Revised
Endangered Species Act - Section 7 Consultation
Biological Opinion

Santiam Water Control District (SWCD) Canal Fish Screen and Tailrace Barrier Project,
North Santiam River, Marion County, Oregon
(Corps No. 200200720)

Date Issued: July 28, 2003

Figure 1. North Santiam River Diversions in the Vicinity of Stayton. See Table 1 for key to existing diversions.

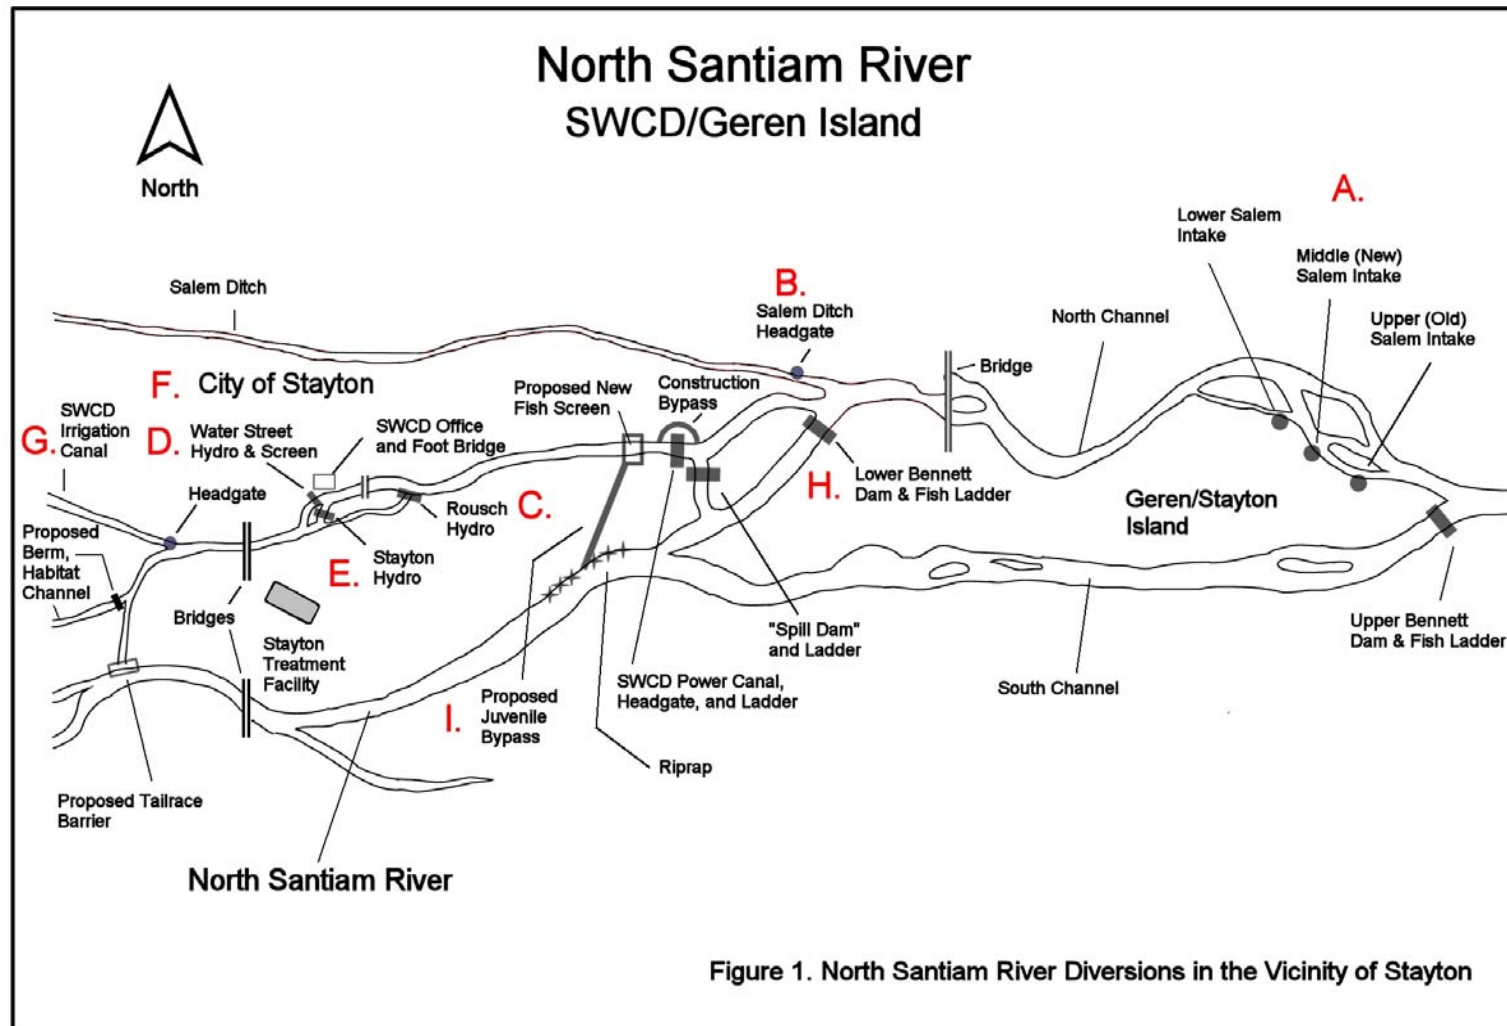
At Upper Bennett Dam, the river is diverted into the north channel. The remaining flows travel over the dam and ladder into the south channel (Figure 1). Upper Bennett Dam operations ensure sufficient flows in the north channel to meet diversions for the City of Salem Geren Island intakes, the Salem Ditch, over the Lower Bennett Dam, and finally in the SWCD power canal. Lower Bennett Dam diverts part of the north channel flows into the SWCD canal while flows over the dam and ladder remain in the north channel, joining the south channel a short distance downstream. Flows in the unscreened Salem Ditch are diverted to the City of Salem, through Mill Creek, and finally to the Willamette.

The proposed new fish screen is sited downstream from the Lower Bennett Dam and fish ladder, in the SWCD power canal, below the existing headgate and ladder (Figure 1). Juveniles traveling through the power canal headgate will be diverted through the proposed juvenile bypass integral to the screen. The bypass pipe will be placed so that fish exit below the confluence of the two channels. When non-consumptive hydropower flows are not directed into the irrigation canal, they can be routed through the proposed tailrace barrier to return them to the river.
